Affected Date Code: *04/18/2023*

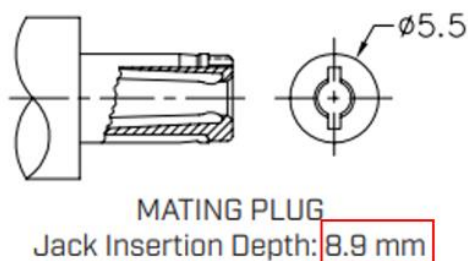
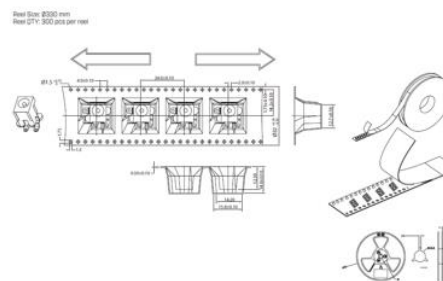
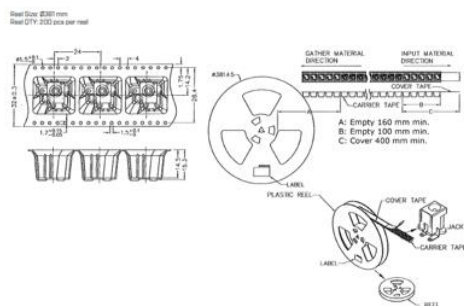
PREVIOUS CUI DEVICES DETAIL / IMAGE			NEW CUI DEVICES DETAIL / IMAGE		
	MATERIAL	PLATING		DESCRIPTION	PLATING/COLOR
center pin	brass	nickel	center pin	brass	nickel
terminal 1	brass	silver	terminal 1	brass	silver
terminal 2	copper alloy	silver	terminal 2	bronze	silver
terminal 3	brass	silver	terminal 3	brass	silver
plastic	PA6T or equivalent		housing	LCP (UL94V-0)	black
			cover	PA6T (UL94V-0)	black

PREVIOUS CUI DEVICES DETAIL / IMAGE					NEW CUI DEVICES DETAIL / IMAGE						
<b>SOLDERABILITY</b>					<b>SOLDERABILITY</b>						
parameter	conditions/description	min	typ	max	units	parameter	conditions/description	min	typ	max	units
reel storage	at relative humidity <math>\leq 80\%</math>			40	$^{\circ}\text{C}$	reel storage	$\leq 30^{\circ}\text{C}$ , $\leq 80\%$ humidity				$^{\circ}\text{C}$
reflow soldering <sup>1</sup>	see reflow profile	255	260	265	$^{\circ}\text{C}$	reflow soldering <sup>1</sup>	see reflow profile		260		$^{\circ}\text{C}$
drying conditions <sup>2</sup>	parts in reel: bake at $40^{\circ}\text{C}$ $\pm 5^{\circ}\text{C}$ for 72 hours parts removed from reel: bake at $40^{\circ}\text{C}$ $\pm 5^{\circ}\text{C}$ for 10 hours					drying conditions <sup>2</sup>	parts in reel: bake at $40 \pm 5^{\circ}\text{C}$ for 72 hours parts removed from reel: bake at $40 \pm 5^{\circ}\text{C}$ for 10 hours

<small>Note:</small> 1. Must reflow solder within 72 hours from opening vacuum packaging at a temperature $\geq 130^{\circ}\text{C}$ @ relative humidity $\leq 80\%$ . 2. When exposing from $40$ to $125^{\circ}\text{C}$ .					<small>Note:</small> 1. CUI Devices recommends to solder within 72 hours from opening vacuum packaging at a temperature $\geq 130^{\circ}\text{C}$ @ relative humidity $\leq 80\%$ .
